**20 May 10**  
**Addendum # 2**

**RFP # 7325671**

**Title: ARRA- Design-Build of Fire Alarm Systems and Sprinkler Systems @ RI College  
(Horace Mann & Fogarty Life Science.**

101 RHODE ISLAND COLLEGE Whipple Hall

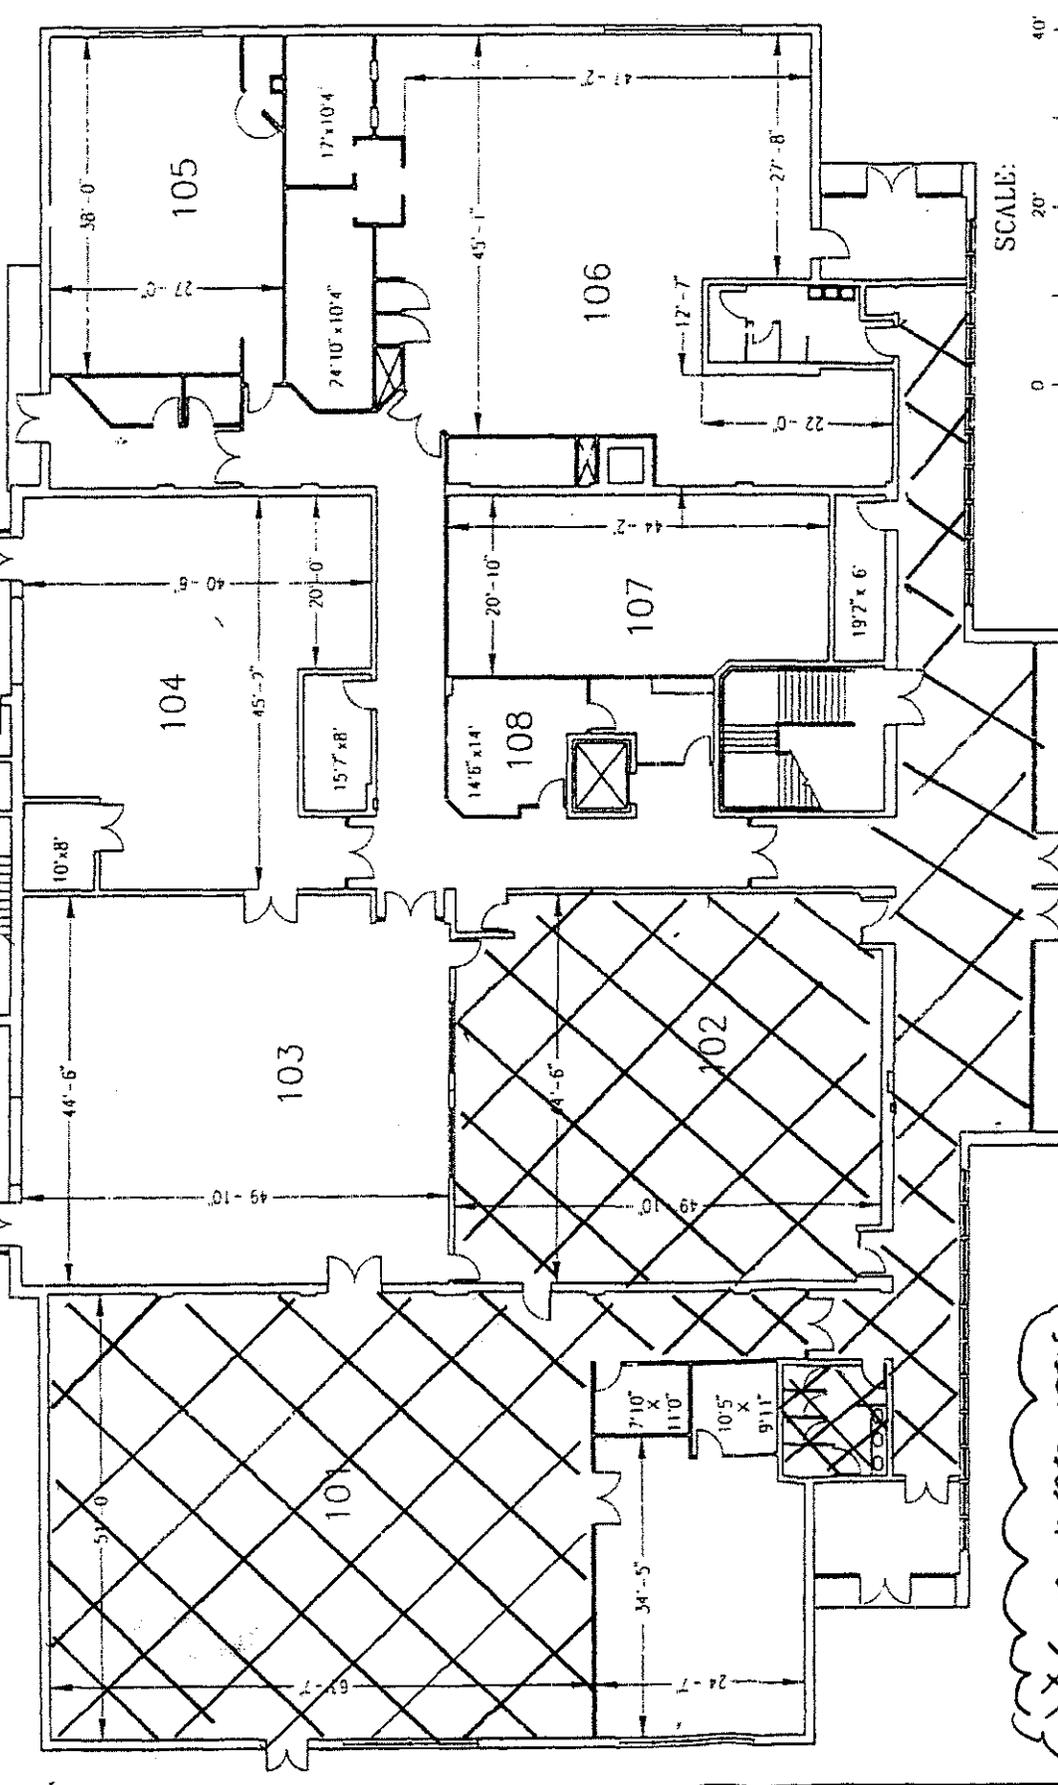
- Is there any detection above the ceiling? *No*
  - Is there duct detection? *Yes*
  - Where is there existing sprinkler coverage? *There is sprinkler coverage in front lobby, first floor ladies room, room #102, and room #101 only (see attached drawing)*
